STAFF SUBMITTAL

Application for Stream Channel Alteration Permit (SCAP.2621.3) for
Temporary By-Pass Roads and Replacement of Makaha Bridges 3 and 3A, Makaha Stream, Makaha,
Oahu (TMKs: (1) 8-4-001:012, 8-4-002:045 and 47, 8-4-008:020 and 8-4-018:014)

Figure 1-2 Tax Map Keys (TMKs)
Replacement of Mākaha Bridges No. 3 and No. 3A
 Farrington Highway, Wai'anae, O'ahu, Hawai'i
 State Department of Transportation, Highways Division

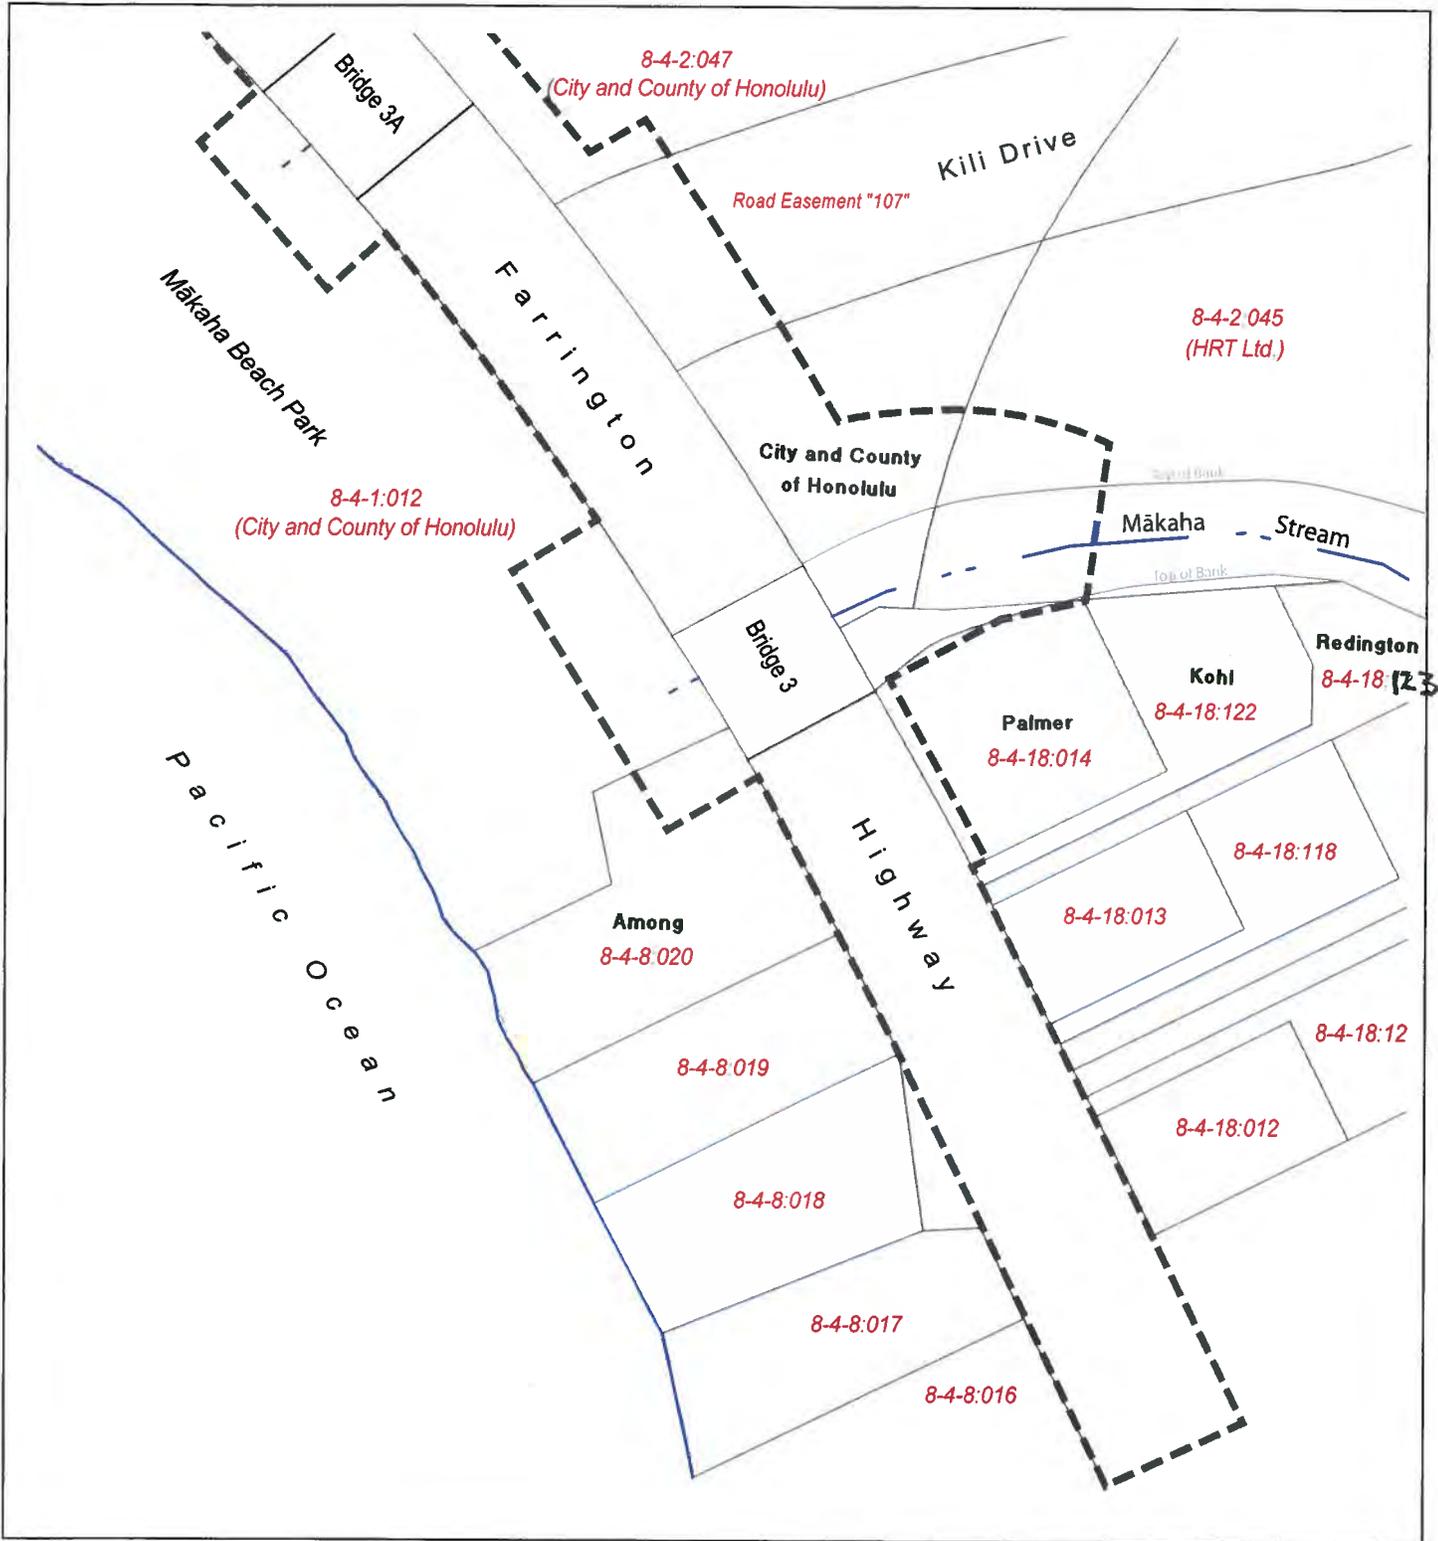
"Figure 1-2 line showing "top of embankment" on Kili Drive side of Makaha stream is not correct, does not show inflow of water and eaten away embankment across from 84-452 Farrington Hwy, TMK 1-8-4-018-122 and 413-C as described newly appearing large volume flow, maybe from makaha Stream West."

"Page 1-2 and 1-3 drawings are not even consistent as to the location and direction of the Makaha Stream. Yet these are dated February 2010 and April 2010. Why the change?"

The two figures cited above reference the same project site but serve different purposes: Figure 1-1, Project Location, is based on the topographic base map for this project and is intended to show the general location of the project site in relation to its immediate surroundings.

Figure 1-2, Tax Map Keys (TMKs), is based on a program called Win2Data that shows only parcel boundaries, the stream centerline and the shoreline. The orientation of this map is also different from Figure 1-1, as noted by the north arrow. In short, these are two different maps showing different themes (subjects) that serve different purposes.
